**ARCHITECTURAL REVIEW BOARD
CITY OF FREDERICKSBURG, VIRGINIA
AGENDA
May 9, 2016
7:30 P.M.
COUNCIL CHAMBERS, CITY HALL**

ARCHITECTURAL REVIEW BOARD

May 9, 2016

Attachment E.2 – RECOMMENDED SITE PLANNING

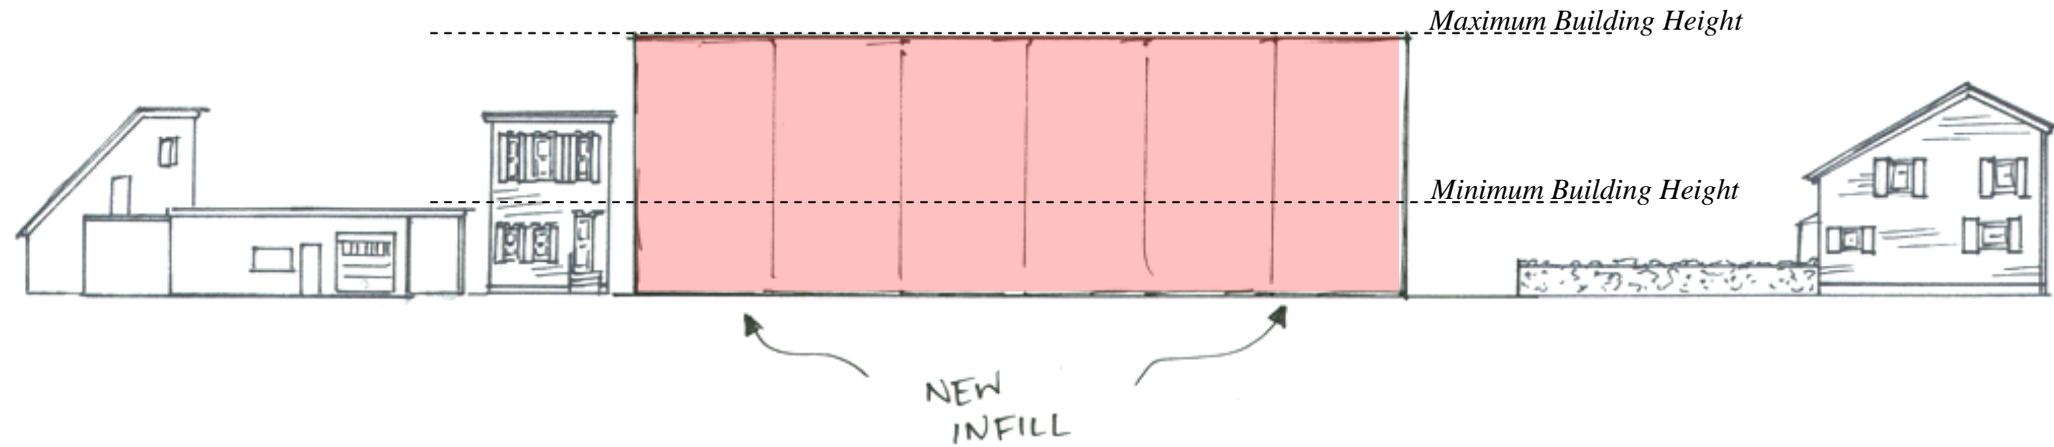
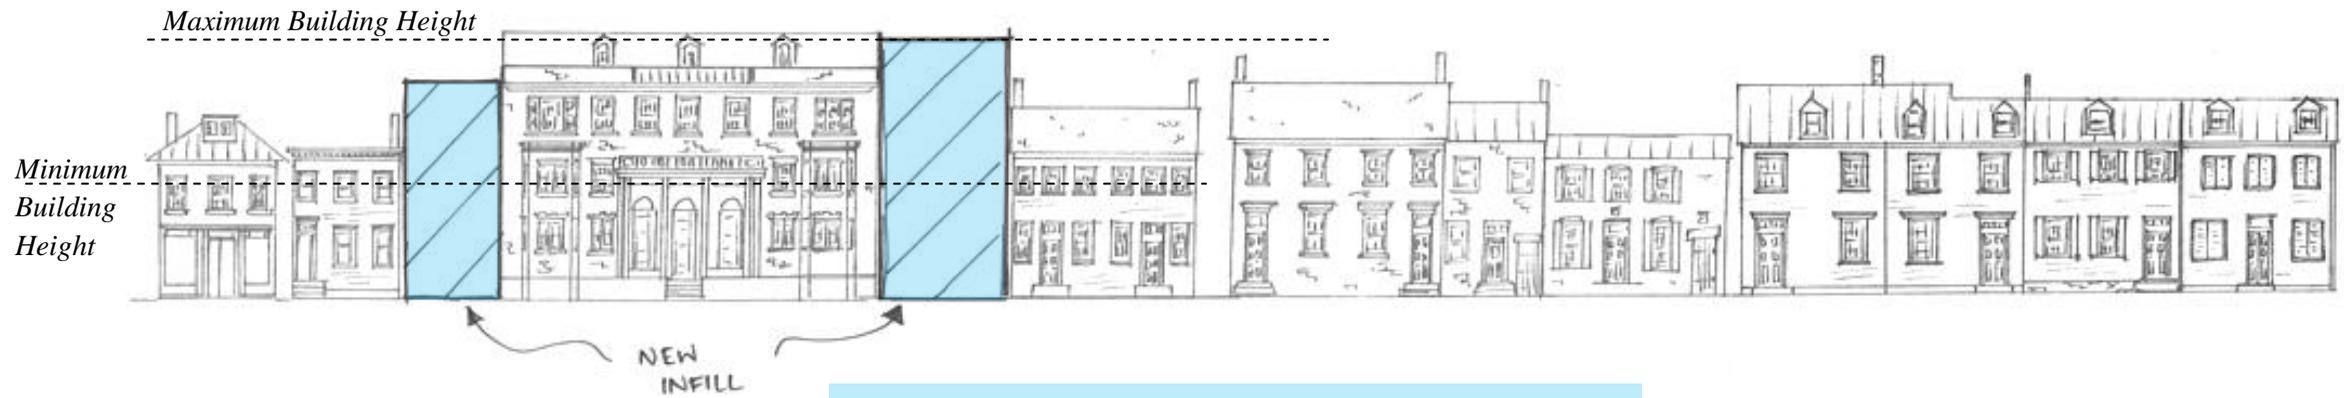
With regards to massing, structures in the district and in the immediate vicinity of the project site typically exhibit relatively narrow facades, with much of the mass extending towards the rear of the lot and/or the center of the block. The Caroline Street block clearly shows this pattern, with most structures ranging from 16-25 feet in width, oriented to the street, and displaying a clear and consistent streetscape. The pattern is also visible on Sophia Street, and is clearly visible when evaluating the historic Sanborn maps. Divisions in the façades of the proposed townhomes are generally consistent with adjacent structures, and the pattern of entrance and porch projections is appropriate for the district. However, the side-oriented unit (B2 on Attachment A) breaks with typical historic patterns of development. For this building, main entrances are accessed via a service drive and individual driveways are a primary feature. This arrangement creates a break in the streetscape and is incompatible with the character of the block and the Historic District.
